Tax ID # 04-373391
ON-SITE SEWAGE DISPOSAL SYSTEM
HOWARD COUNTY HEALTH DEPARTMENT
BUREAU OF ENVIRONMENTAL HEALTH

WTC III Plumbing + Heating IS PERMITTED TO INSTALL ALTER
 ADDRESS: 1820 Gillis Falls Woodbine MD 21797 PHONE NUMBER: 410-489-4457
 SUBDIVISION: McKendree View LOT NUMBER: 1
 ADDRESS: 2319 Meadow Trail Lane PROPERTY OWNER: Jonathan and Juliet Keating

MCKENDREE VIEW
LOTS 1 THRU 8
PLAT No. 19522

2319 MEADOW TRAIL LANE

TRENCH/DRAINFIELD DATA

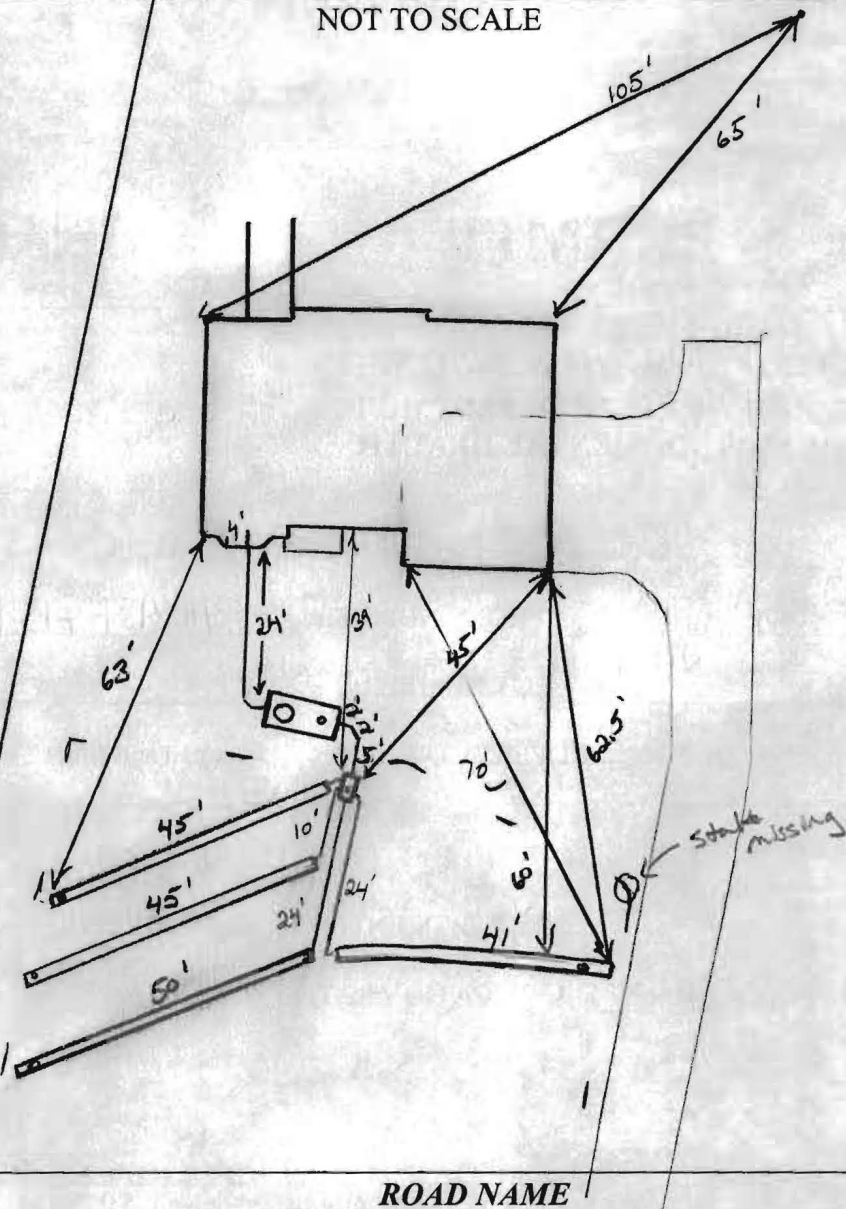
1/10/13 Need to remove fill from septic area. No trenches laid out. Gave tank location. Keep 20' from dwelling. Trench specs adjusted slightly. (KW)

2/11/13 Tank hole dug. Fill removed from s.e.a. top right septic area corner stake not there. Shot contour from original grade. Run 3 x 45' trenches running north and 1 x 45' trench running back towards drive. Bottom trenches on same line contour. OK to run 1 continuous trench but must have 2 pipe's w/ 90° bends into each trench. Call for MSP. (KW)

2/14/13 Tank set. Plumbing installed to Dbox. Top trench completed. OK to continue (KW)

2/15/13 System complete. Dbox leveled. Well line inspected. OK to backfill.

FOUNDATION DETAIL
SCALE: 1" = 30'

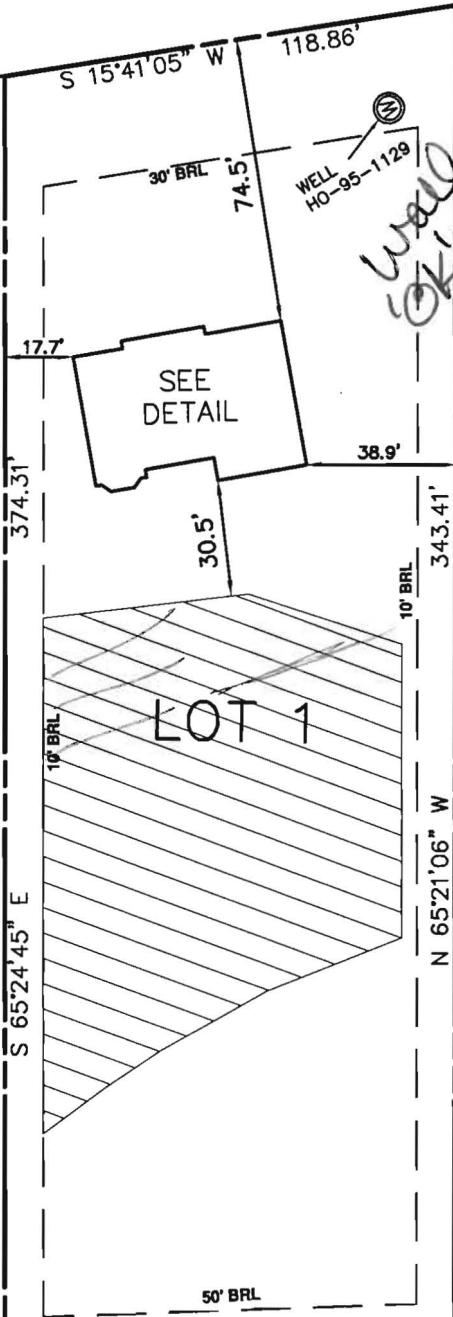
Wall check OK, REB 12/2/2012
